## MEMORANDUM

<b>Date:</b>	November 3, 2014	<b>TG:</b>	14163.00
<b>To:</b>	Tom Hansen, PE – City of Woodinville		
<b>From:</b>	Mike Swenson, PE, PTOE Jesse Birchman, PE, PTOE		
<b>cc:</b>	Maira Haughian – The Blueline Group		
<b>Subject:</b>	Woodinville Church Subdivision – Response to TIA Comments

# Intersection Sight Distance Analysis - NE 205th St

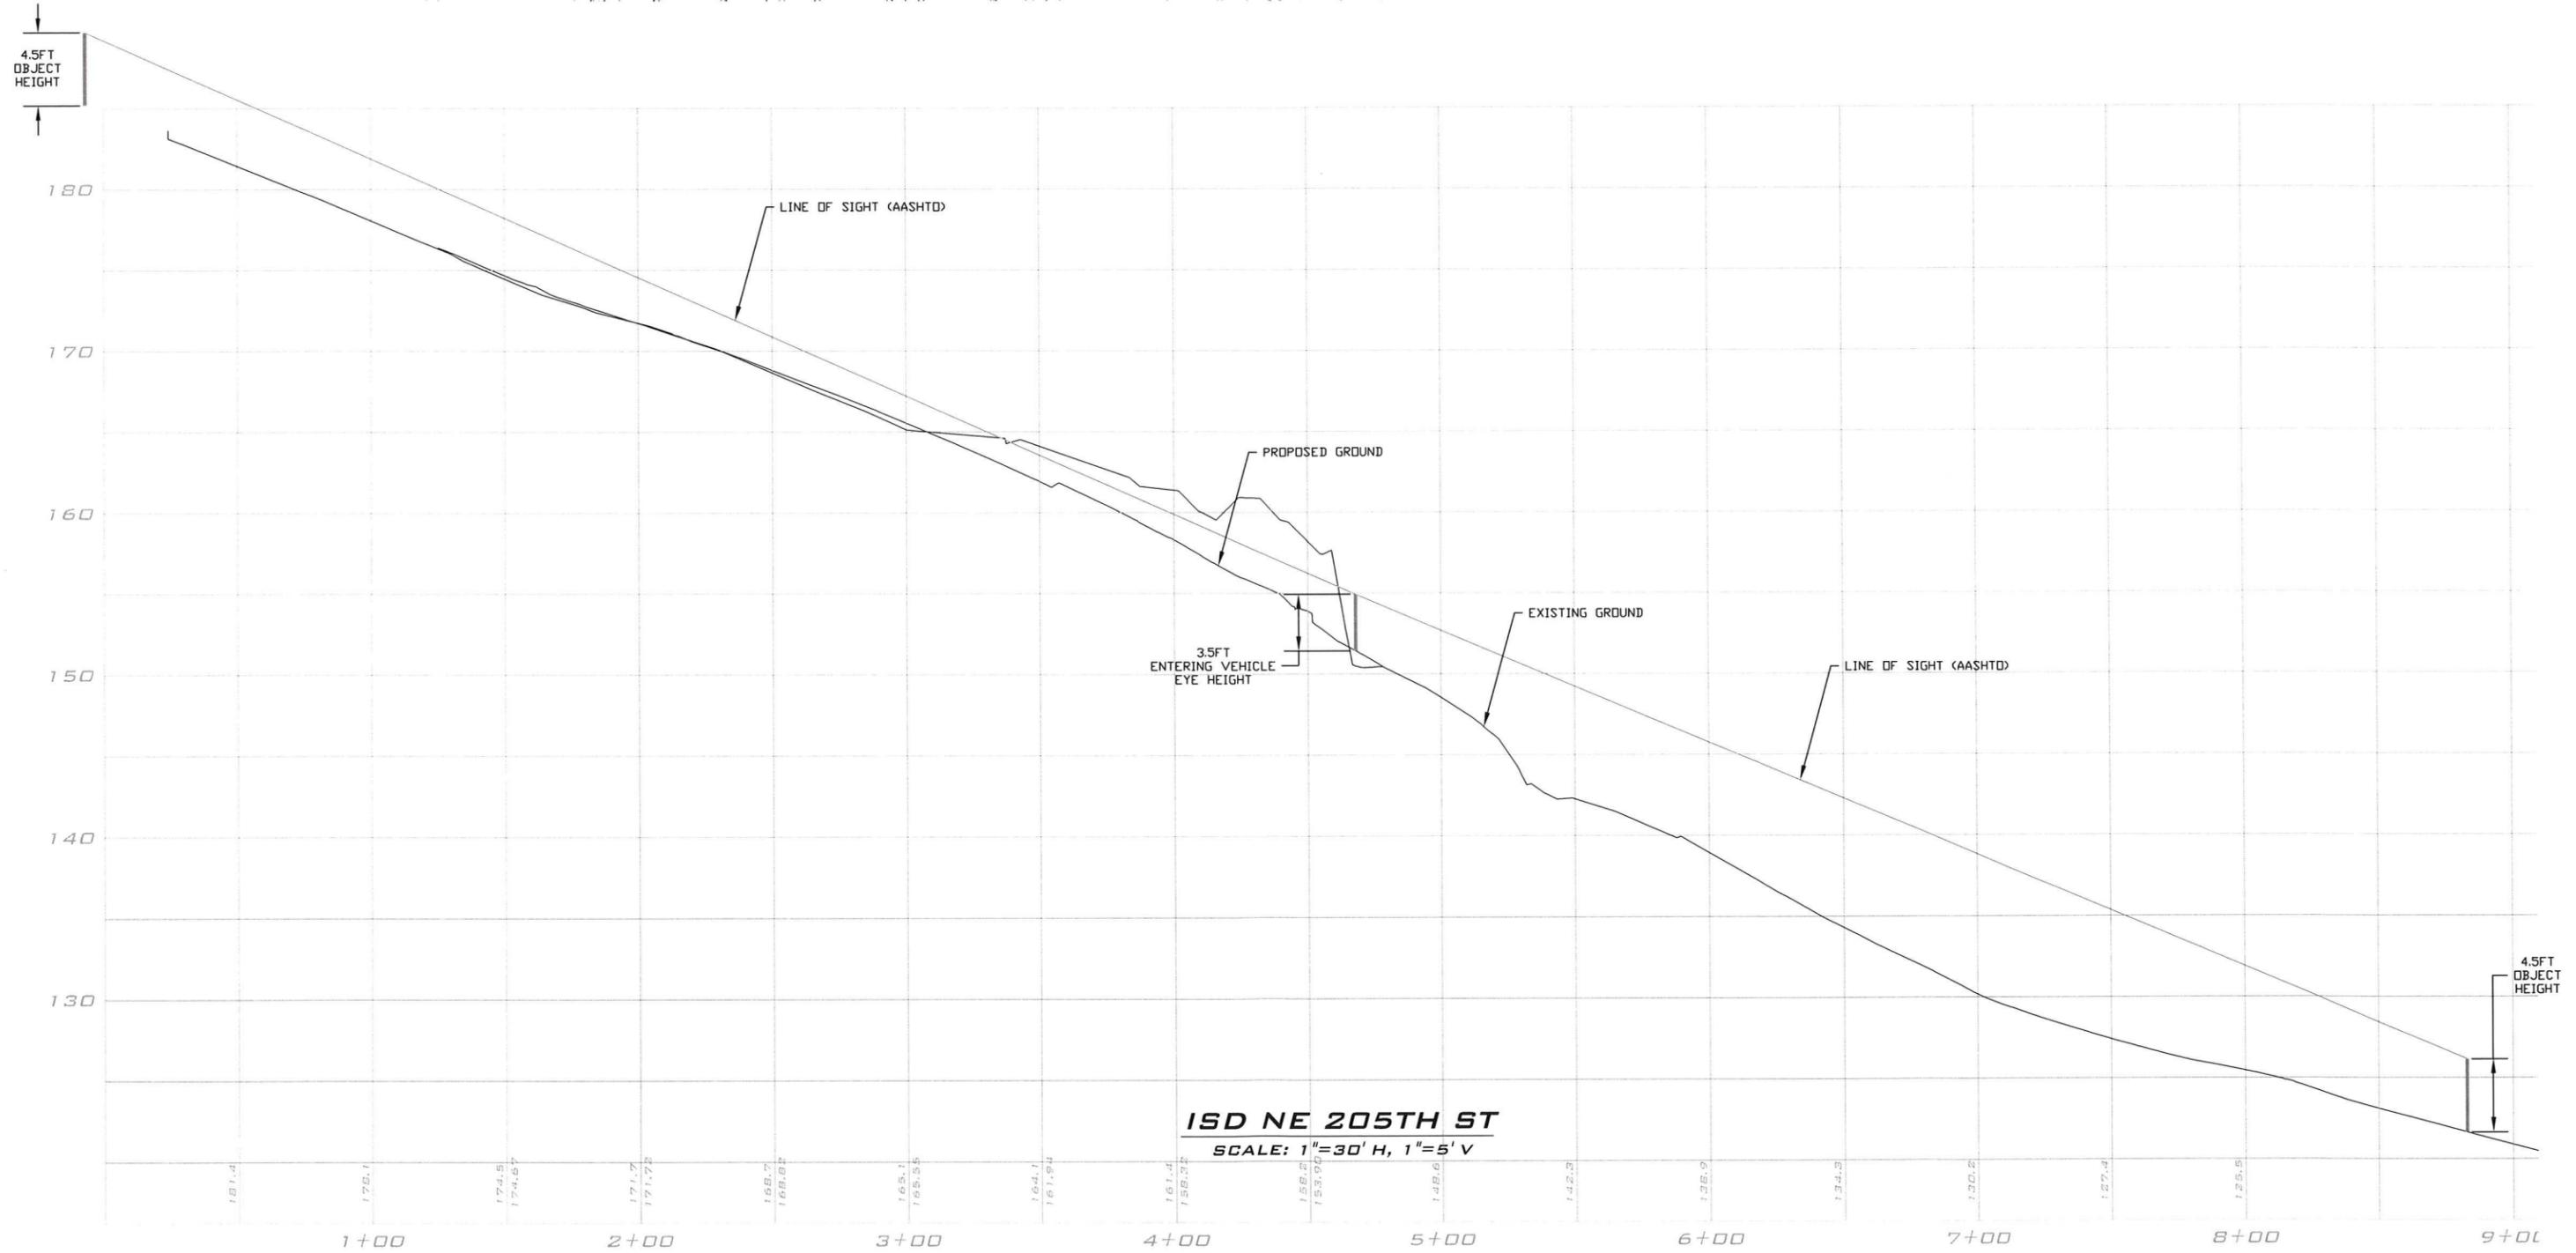
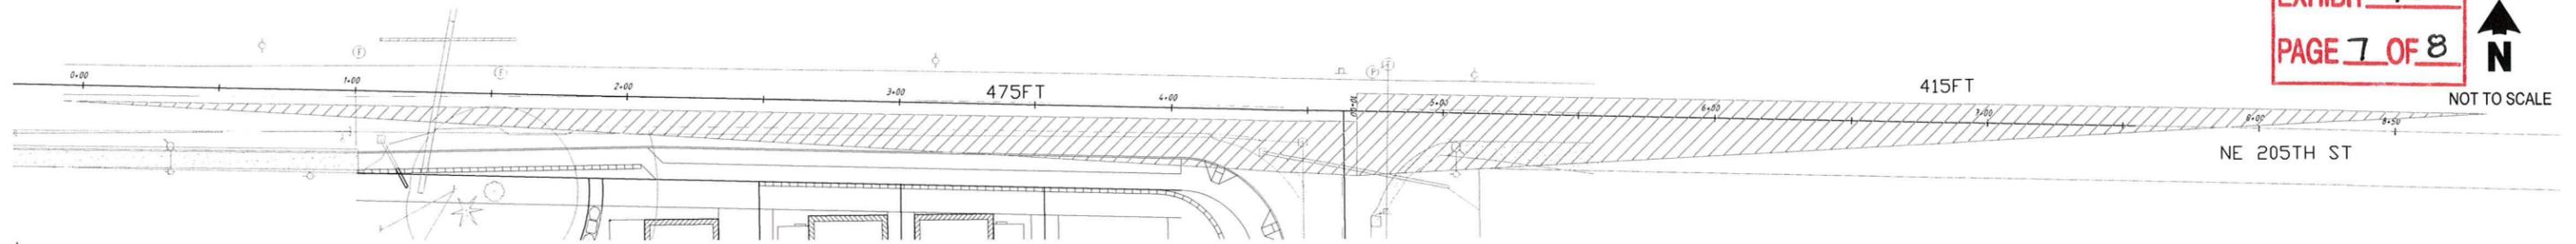
- Concern of low-visibility at the NE 205th Street / 136th Avenue NE intersection
- A request that sidewalk be provided at the NE 205th Street / 136th Avenue NE intersection
- Concern of vehicle speeds along NE 205th Street-244th Street SE

An updated evaluation of sight-distance consistent with AASHTO requirements was completed at the NE 205th Street / 136th Avenue NE intersection and is summarized in Attachments C through Attachment F. This evaluation was based on the proposed site plan provided as Figure 2 within the TIA and includes frontage related improvements. These frontage improvements include curb, gutter, and sidewalk along both NE 205th Street and 136th Avenue NE. As shown in these attachments, sight-lines with these frontage improvements would meet AASHTO design requirements while minimally exceeding City of Woodinville requirements. The provided sidewalks along the proposed project's frontage would connect to the sidewalks currently provided along the frontage of the adjacent parcels.
